Certificate of Appropriateness

Property 729 W. HISTORIC MITCHELL ST. Mitchell Street HD

Description of work Masonry repairs per conditions below and project narrative on following page.

Date issued 8/10/2018 PTS ID 114601 COA: masonry repairs

PILASTER @ LEFT OF CENTER-NORTH FACADE

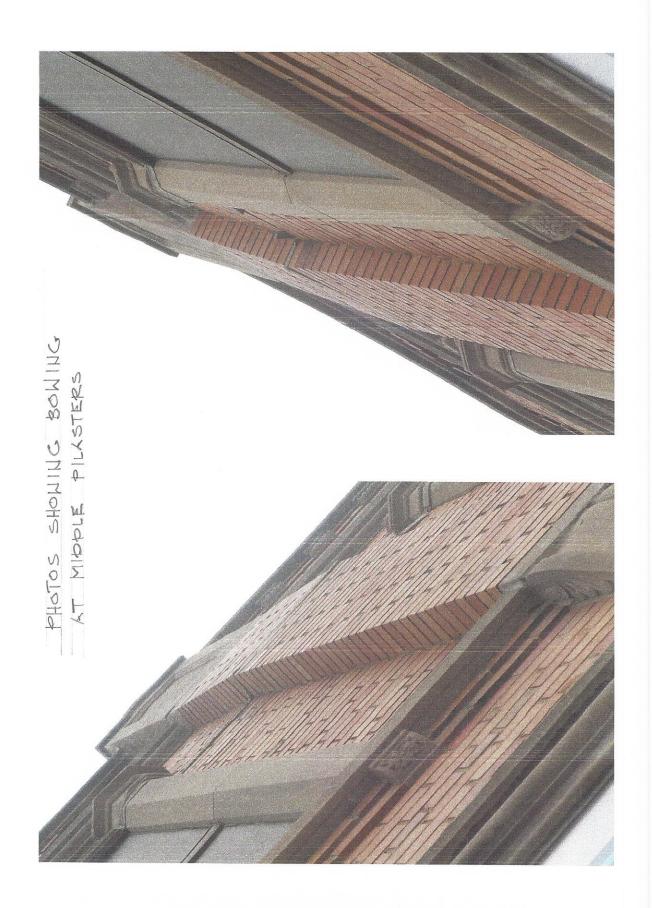
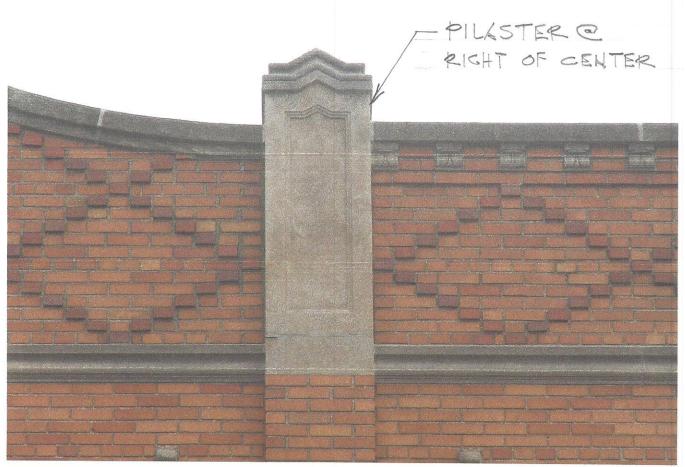
New mortar must match the original mortar in terms of color, texture, grain size, joint width, and joint finish/profile. The compressive strength of the repointing mortar shall be equal or less than the compressive strength of the original mortar and surrounding brick or stone. The replacement mortar shall contain approximately the same ingredient proportions of the original mortar. Mortar that is too hard is subject to premature failure and could damage the masonry. See the city's book *Good for Business*, Masonry Chapters, for more information. In most cases, this means a lime mortar with natural hydraulic cement rather than Portland cement. No joint of a width less than 3/8" may be cleaned of damaged/decomposed mortar with power disc grinders. No over-cutting of the joints is permitted. Remove decomposed mortar back into the wall 2.5 times the height of the joint before repointing. New brick must match as closely as possible the color texture, size, and finish of the original brick. A sample panel of brick and mortar must be reviewed and approved by HPC staff prior to general installation of the material.

REPLIE BRICKS, MORTLE, STONE, SUPPORT & TIE BLOCK TO STRUCTURE

LINTEL REPAIR:

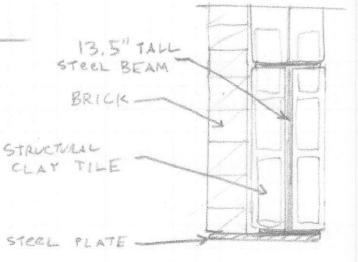
* STEEL PLATE AND BOTTOM FLANGES ARC RUSTED SEVERELY ABOVE WINDOWS.

* INSTALL 6×6×1/4" (MIN) ANGLE
PENDING MORE ACCURATE MEASUREMENT
OF HOLIZONTAL MOVEMENT
(UP TO L8×8×3/8" MAY DE NEEDED)
